CONTAINMENT PIPING PENETRATIONS AND VALVING

DCPP UNITS 1 & 2 FSAR UPDATE

FSAR UPDATE
UNITS 1 AND 2
DIABLO CANYON SITE
FIGURE 6.2D-8A
DEPS Minimum SI Sump Temperature Comparison

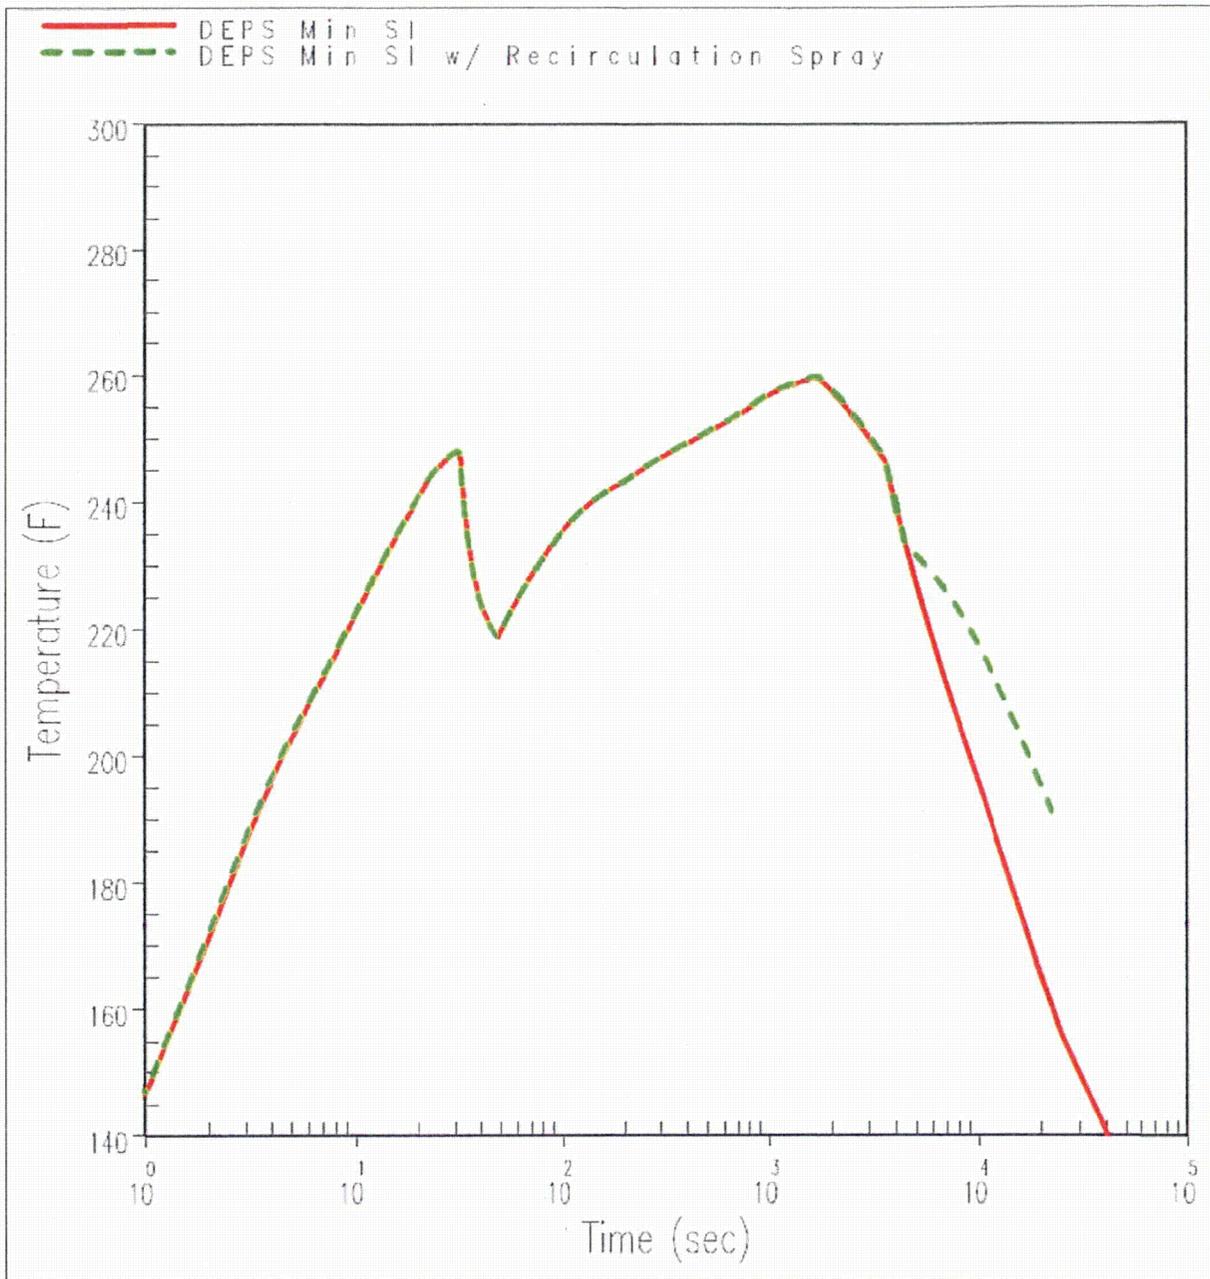
An assessment was performed to evaluate the effect of operation of containment spray in the recirculation mode following a LOCA on the sump water temperature transient. As shown in Figure 6.2D-8A, the sump water temperature transient is effected only in

the long-term (i.e., after initiation of recirculation spray) at which time it becomes more limiting due to increased heat addition from the containment atmosphere to the sump fluid by the containment recirculation sprays which is credited to operate for approximately 6.25 hours. The effect of this increase in temperature on the performance of the CCW system is discussed in Section 9.2.2.3.13.

During the recirculation mode, the CCW system is design to remove the heat from the sump (via the RHR heat exchanger) to provide recirculation spray (refer to Section 6.2.2) and emergency core cooling (refer to Section 6.3). Figure 6.2D-8A provides the comparison between the containment sump temperature profile with minimum safeguards, and with and without recirculation containment spray. As shown in Figure 6.2D-8A the long-term sump water temperature with credit of recirculation spray is more limiting for the CCW system due to increased heat addition to the sump from the containment atmosphere by sprays. However, in both cases the predicted CCW temperatures during LOCA conditions are still within the limits of the CCW system temperature acceptance criteria; i.e., a maximum post-accident supply temperature of 140°F for a period of up to 6 hours, and a maximum 6-hour long-term continuous supply temperature of greater than 120°F.
